ADDENDUM NO. 2 TO PROJECT NO. 45011

**CONSTRUCTION WORK, HVAC WORK, PLUMBING WORK, ELECTRIC WORK
PROVIDE COMBINED SUPPORT MAINTENANCE SHOP
CAMP SMITH
11 BEAR MOUNTAIN BRIDGE ROAD
CORTLANDT, MANOR, NY 10567**

August 5, 2015

WALL SECTION-ADMIN PARAPET

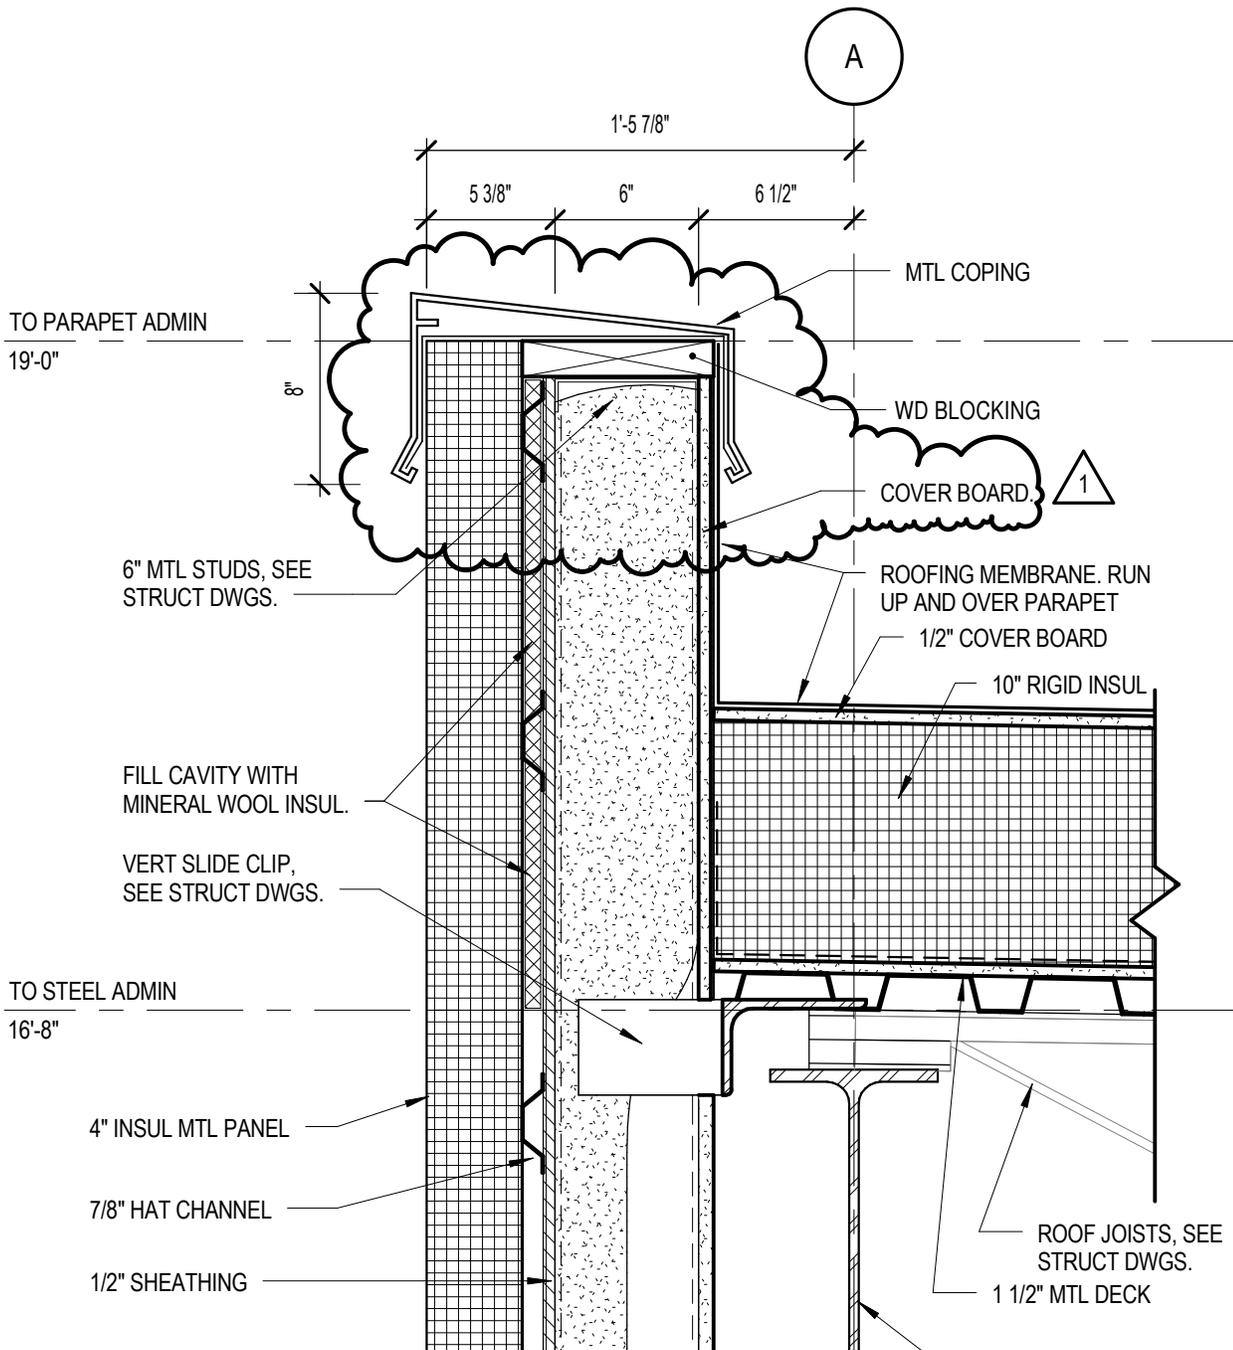
- b. Detail C5; replace detail with 11”x17” JD-A1 Addendum Drawing dated August 3, 2015.
 - c. Detail D2; Replace detail with 8 1/2”x11” JD-A2 Addendum Drawing dated August 3, 2015. Change wording “Exterior Sheathing” at back side of parapet to “Cover Board”. Extend spray foam insulation full height of parapet cavity.

SHEET TITLE:
 ADDM #2

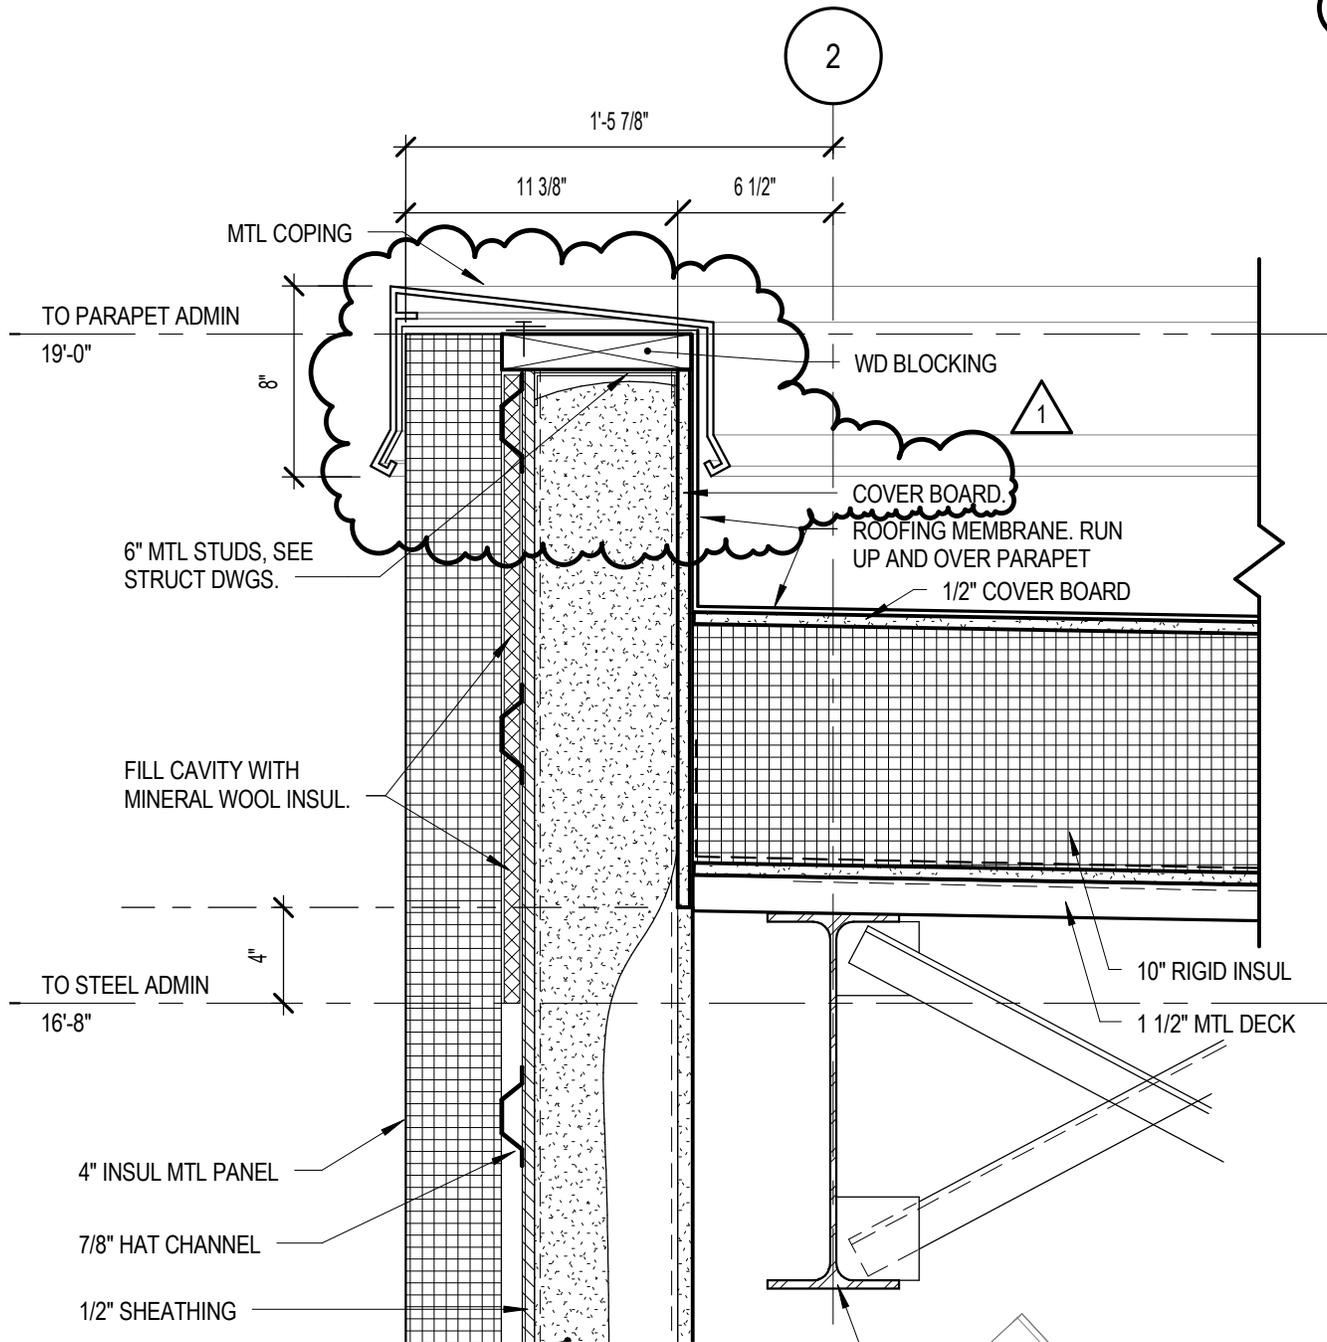
- d. Detail D3; Replace detail with 8 1/2”x11” JD-A3 Addendum Drawing dated August 3, 2015. Change wording “Exterior Sheathing” at back side of parapet to “Cover Board”. Extend spray foam insulation full height of parapet cavity. Show continuous hold down clip at metal coping.

ENLARGED PLAN-TLT/SHOWER RMS

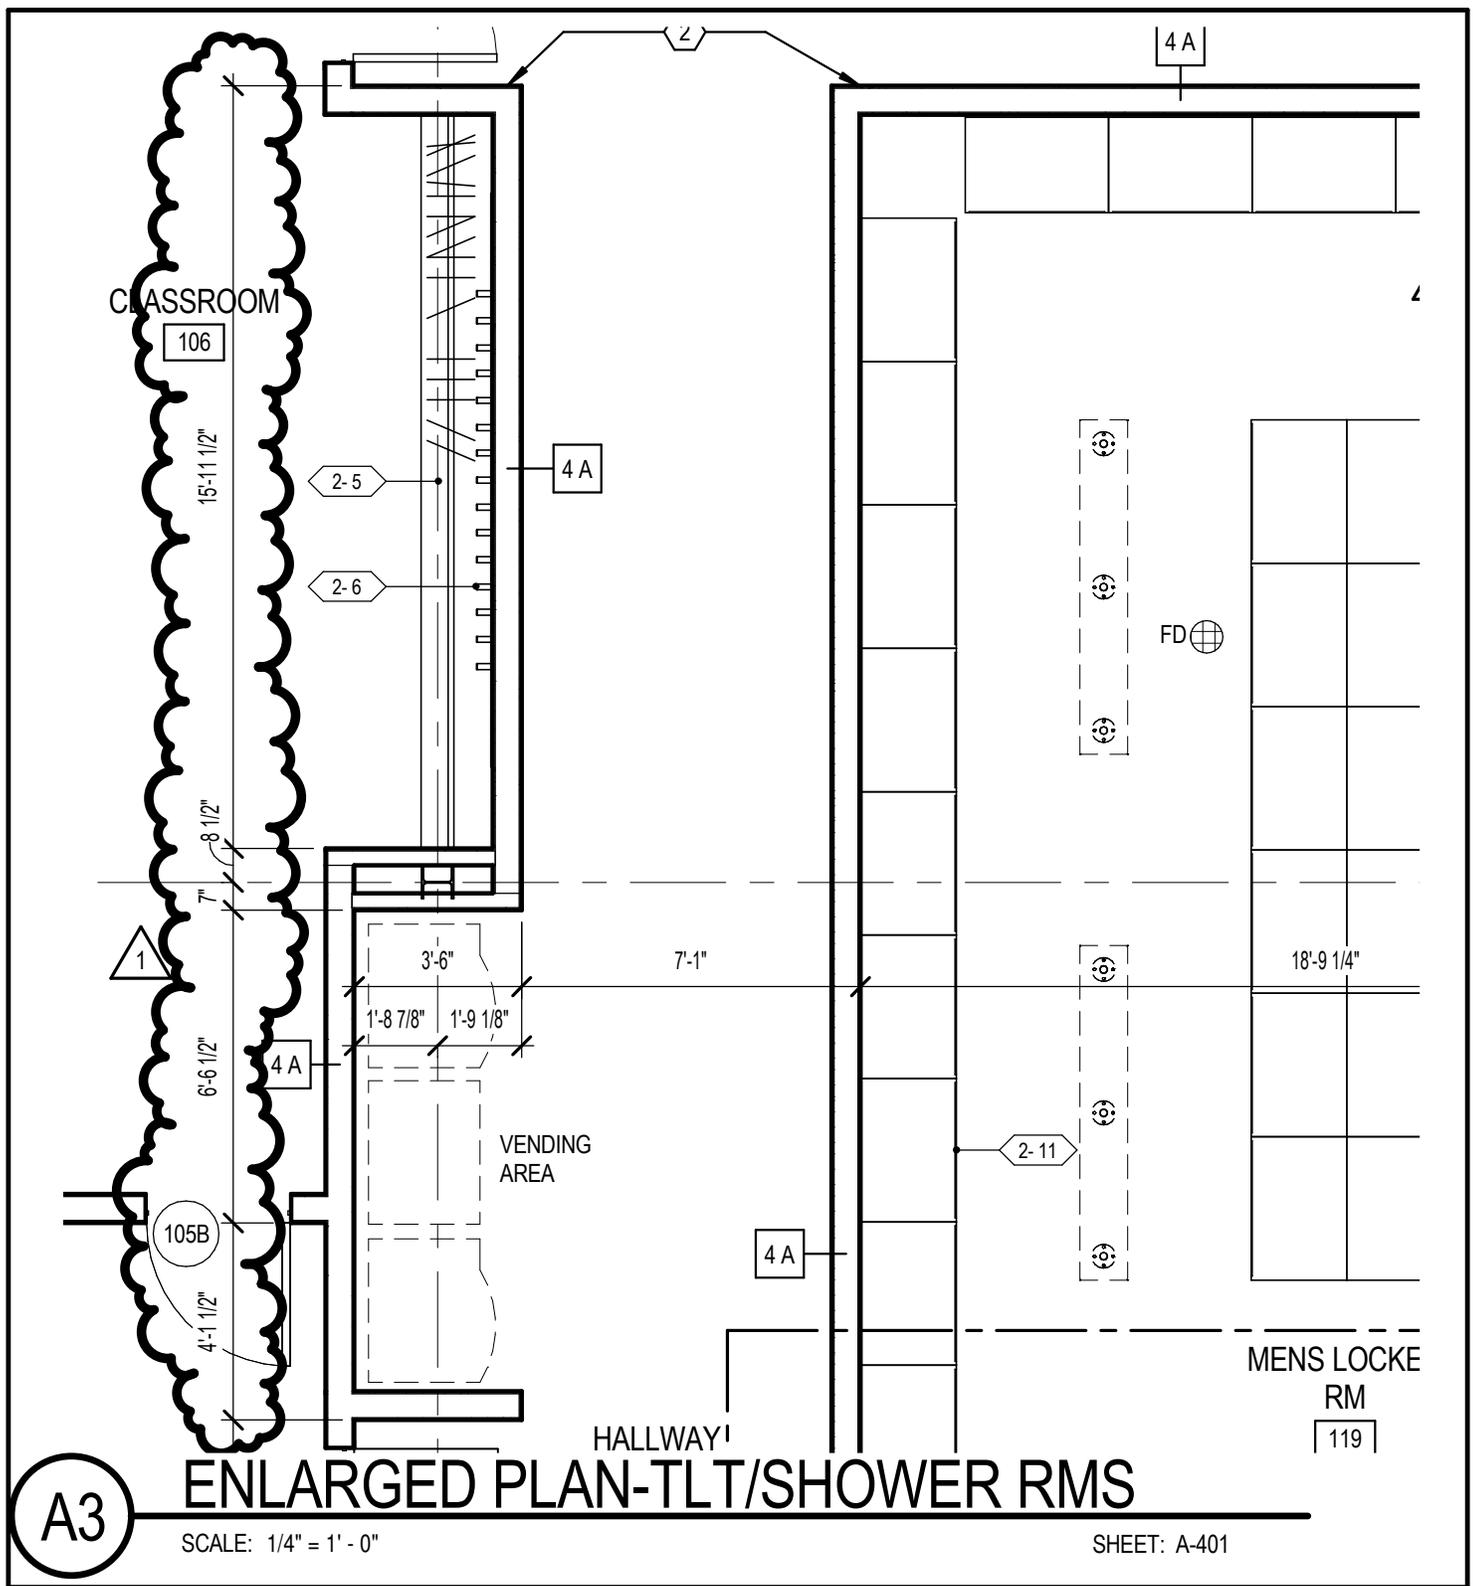
6. Drawing No. A-401, A3 Enlarged Plan – Toilet/Shower Rooms
 - a. Add dimensions per 8 1/2”x11” JD-A4 & 8 1/2”x11” JD-A5 Addendum Drawings dated August 3, 2015.

ENLARGED PLAN - MECH MEZZ

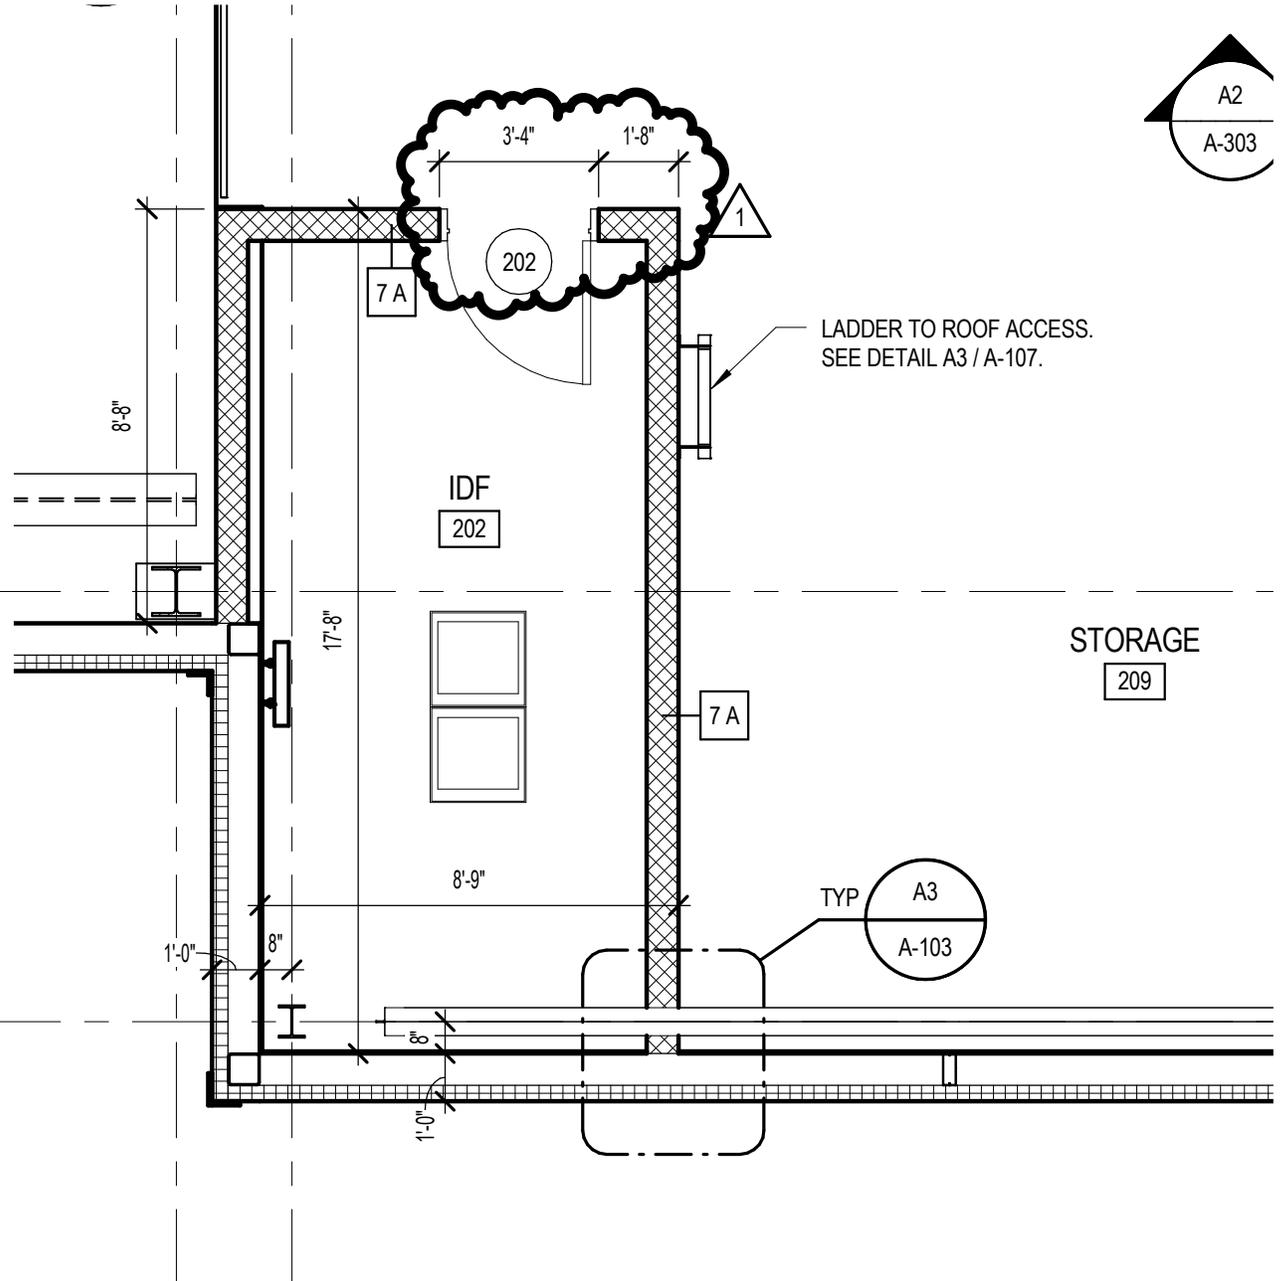
7. Drawing No. A-402, A5 Enlarged Plan – Mech Mezz
 - a. Add dimension to CMU wall at hinge side of Door 202 as shown in 8 1/2”x11” JD-A6 Addendum Drawing dated August 3, 2015.

PLAN DET - WALL INTERSECTION (HIGH)

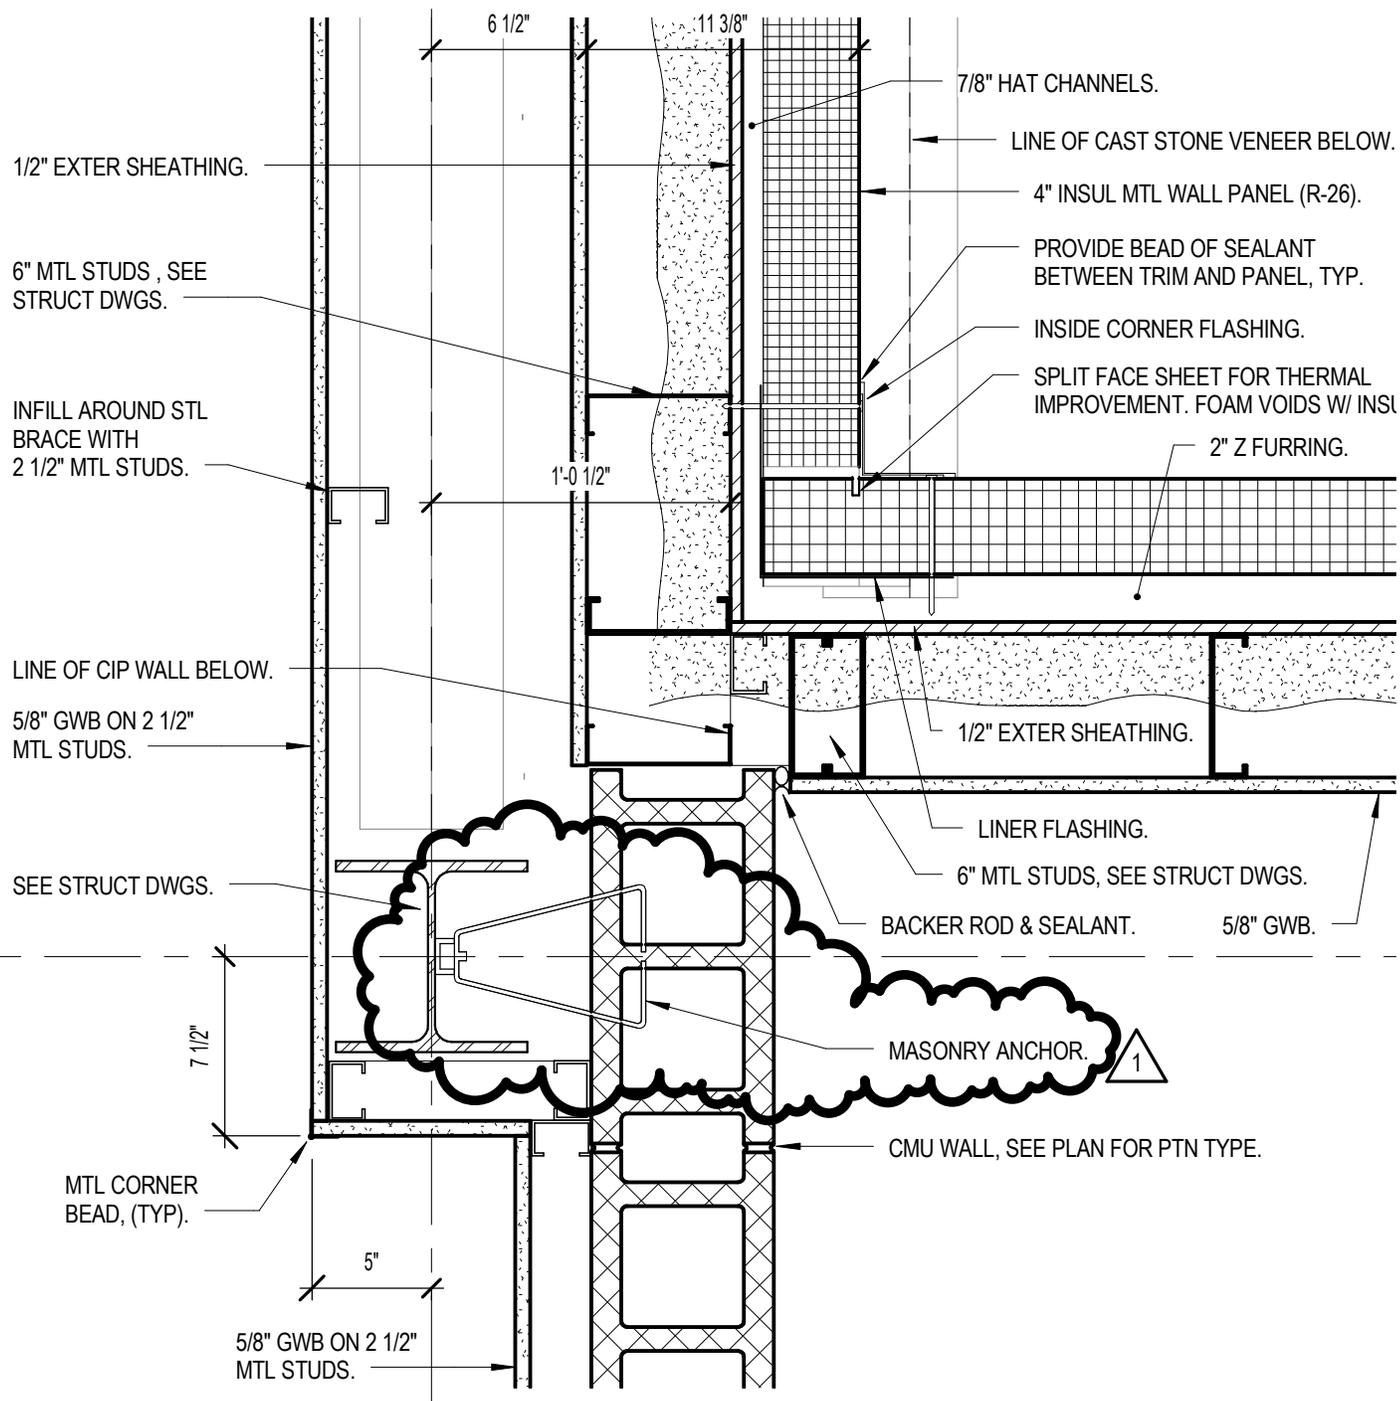
8. Drawing A-501
 - a. Detail B1, replace with JD-A7 Addendum Drawing dated August 3, 2015. Add adjustable masonry anchor at Column C.2/3.2.
 - b. Detail D5, replace with JD-A8 Addendum Drawing dated August 3, 2015. Add adjustable masonry anchor at Column 1/E.
